ALERT SERVICE BULLETIN

210-22-16

MODEL AFFECTED: 210

SUBJECT: MAIN ROTOR SCISSORS & SLEEVE HUB
ASSEMBLY COLLECTIVE 204-011-405-013
IDENTIFICATION

Figure 1 – Hub Assembly Ink-Stamped Part Number and Serial Number

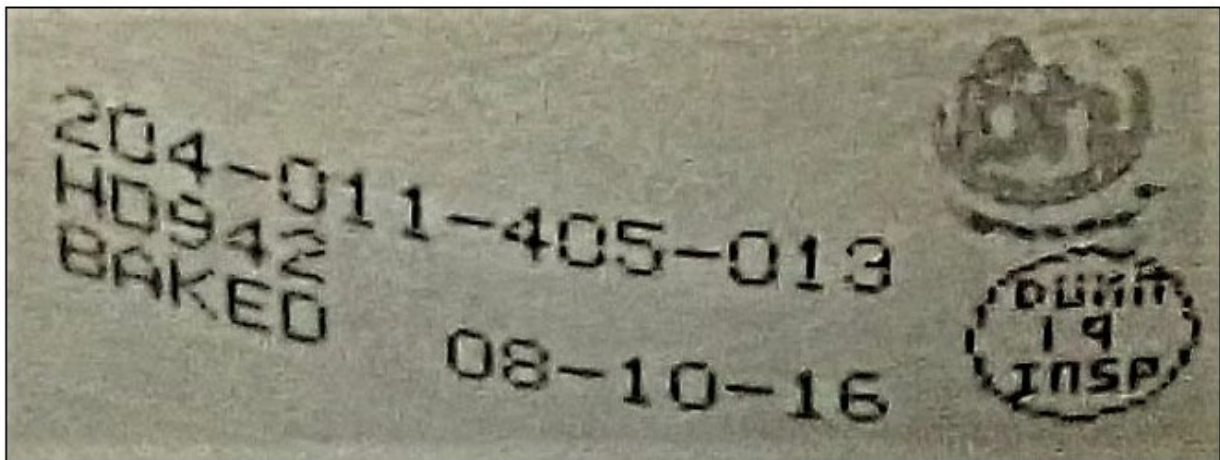
2. Confirm if there is a Historical Service Record (HSR) for the Hub Assembly (204-011-405-013) and that it contains the serial and part numbers.
3. Gain access to the Hub Assembly 204-011-405-013 and inspect for the presence of part number and serial number matching the Historical Service Record (HSR) at the location shown on Figure 1.

4. If the Hub Assembly is not correctly marked, as shown in Figure 1, proceed with **PART II**.
5. If the Hub Assembly is correctly marked, as shown in Figure 2, make an entry in the helicopter logbook and historical service records indicating findings and compliance with **Part I** of this Alert Service Bulletin.

2. If the Hub Assembly has an ink-stamped part and serial number matching the HSR (refer to example shown in Figure1), permanently mark the part and serial number on the Hub Assembly by vibro-etching or dot-peening (Figure 2).
3. If the Hub Assembly does not have a part number and serial number, create a unique serial number for each Hub Assembly. Using one or two prefix letters consistent with the company name of the operator or repair facility accompanied by a dash and 4 or 5 digits is considered as an industry serial number marking standard. Vibro-etch or
